1 7/21/2021 1ST REVIEW FROM TOWN OF ROLESVILLE CONSULTANT, WAKE COUNTY OF KALEIGH

KALAS FALLS
PHASE 3
32 ROLESVILLE ROAD
WAKE COINTY NO

DATE: FEB 18, 2021
SHEET TITLE:
PHASE 3
UTILITY
PLAN

100 YEAR FLOOD EASEMENT

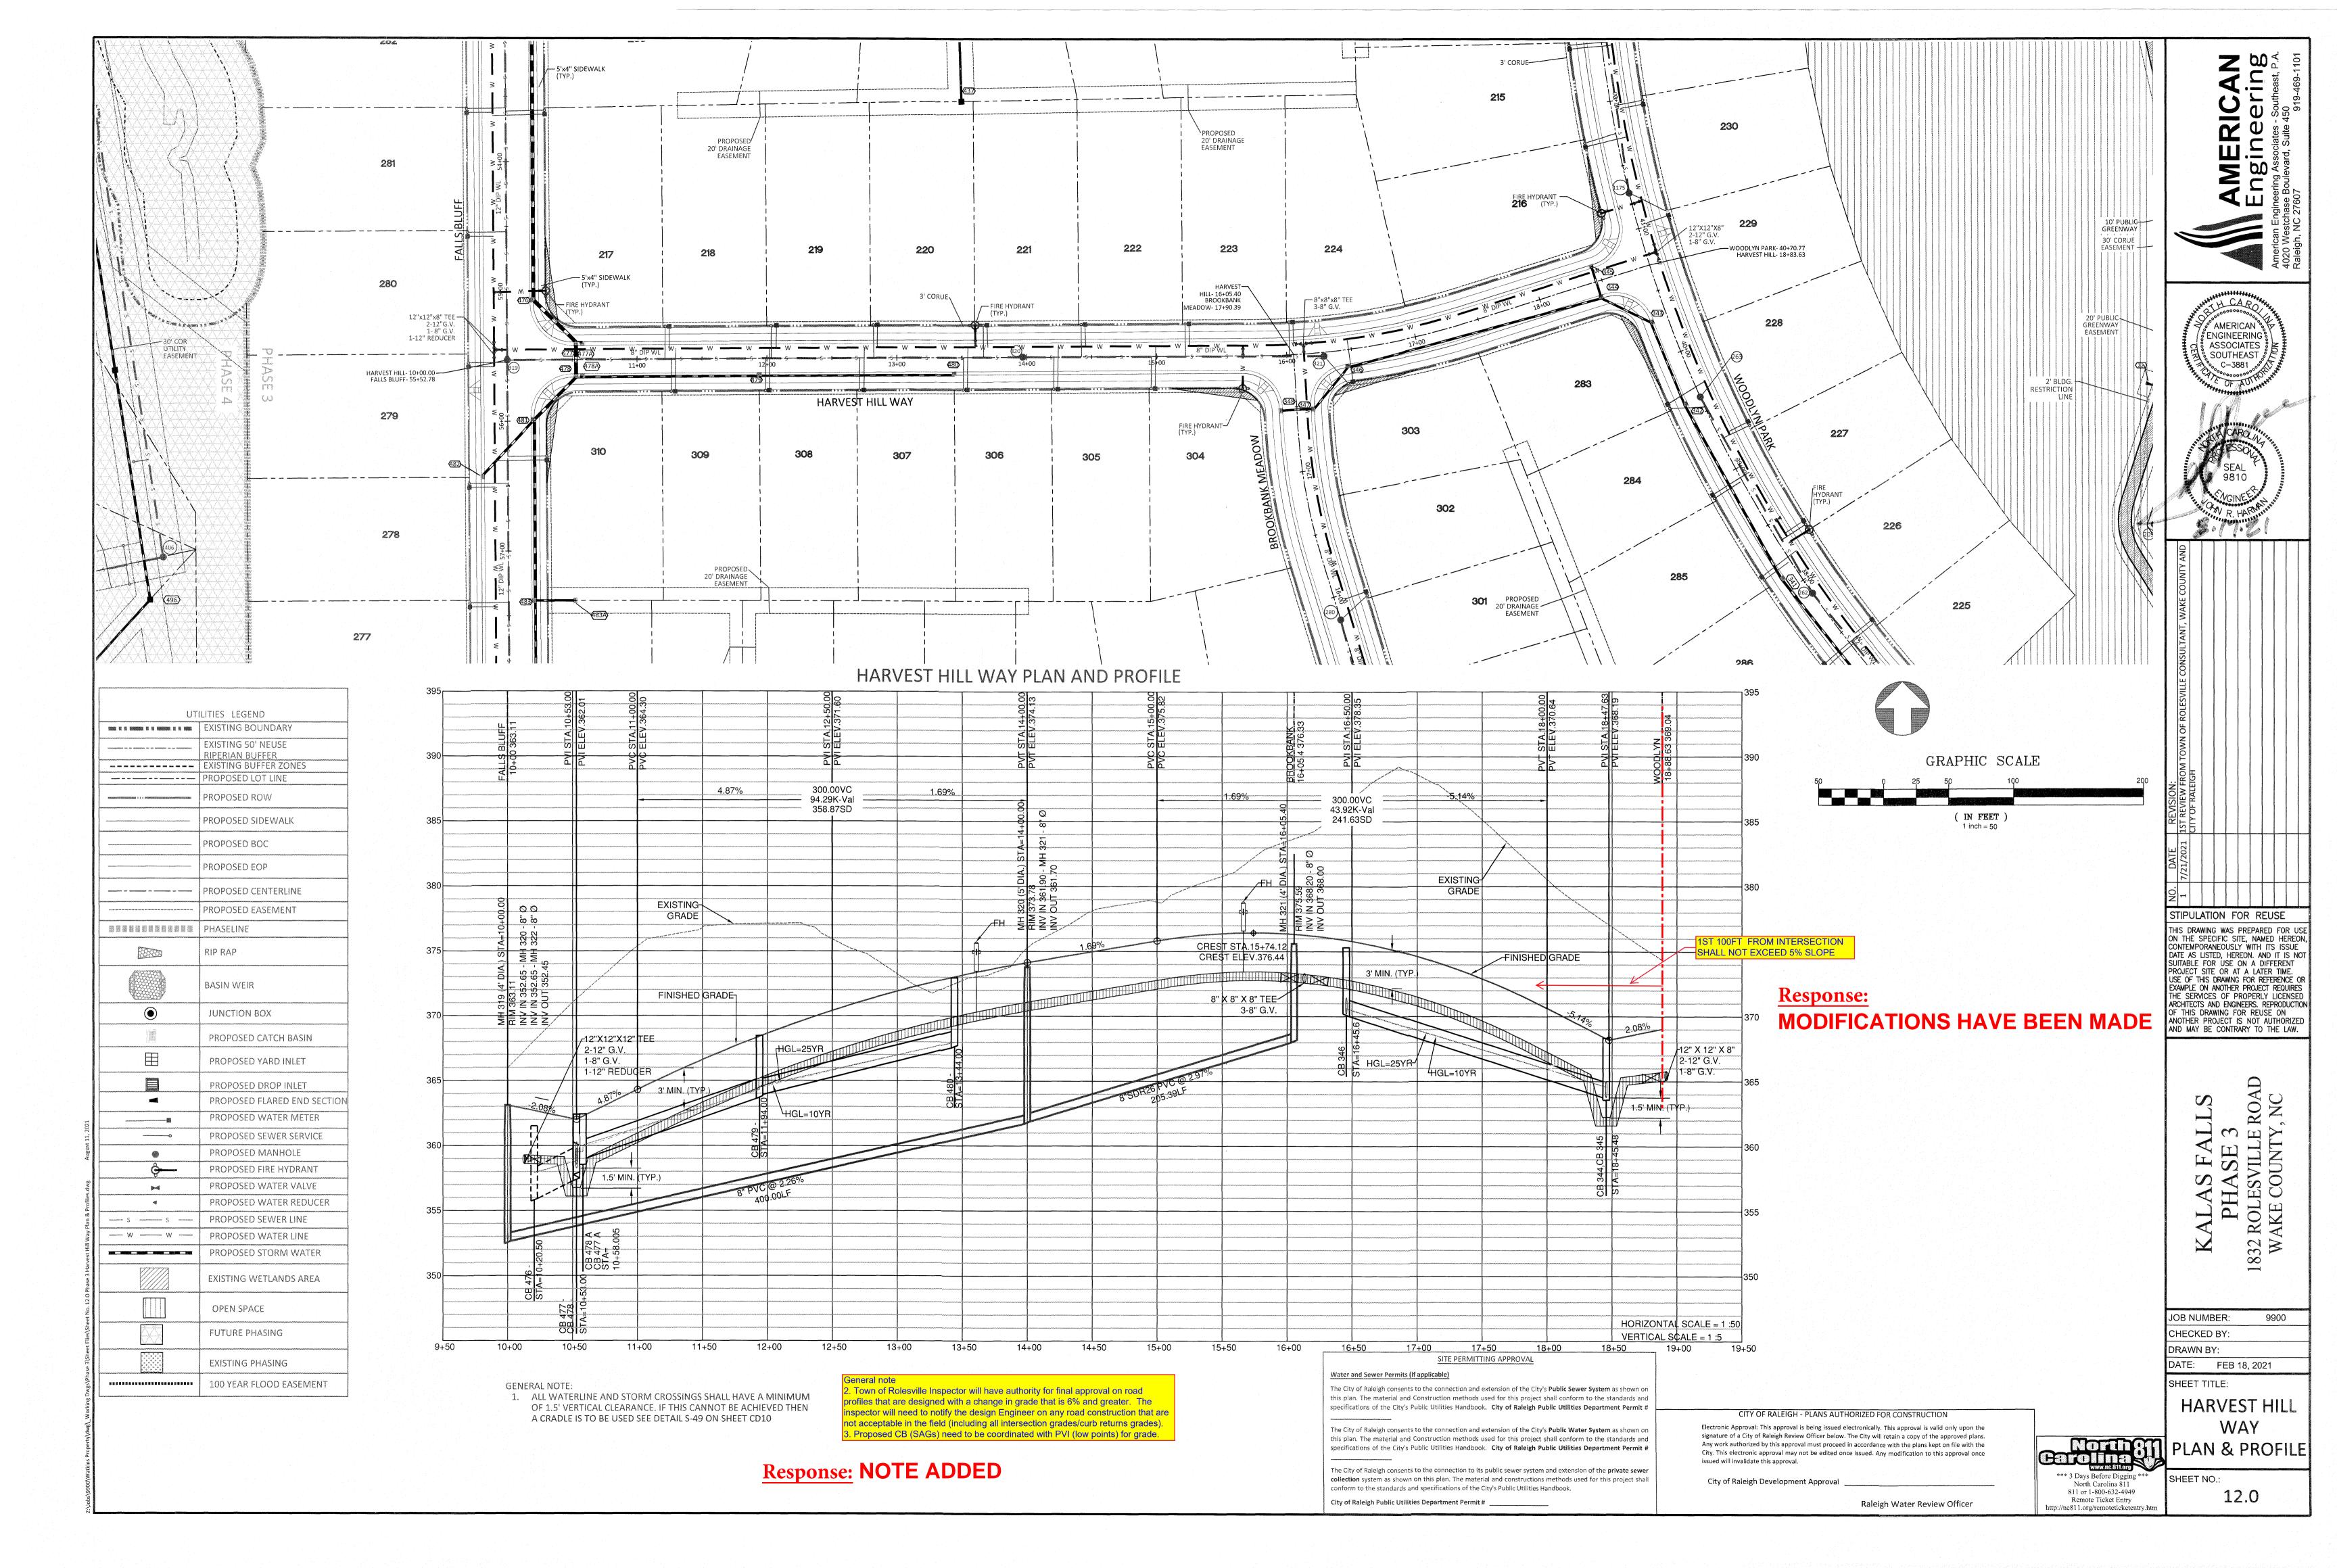
-1ST 100FT FROM INTERSECTION SHALL NOT EXCEED 5% SLOPE Response: This isnt (WHEN ROAD LESS THAN 500', needed per SLOPE MAY BE 150% GREATER) - 7.5% MAX SLOPE FOR 1ST 100 FT conversation the week of 8-26.

> **Response: FIXED**

Response: NOTE HAS BEEN ADDED
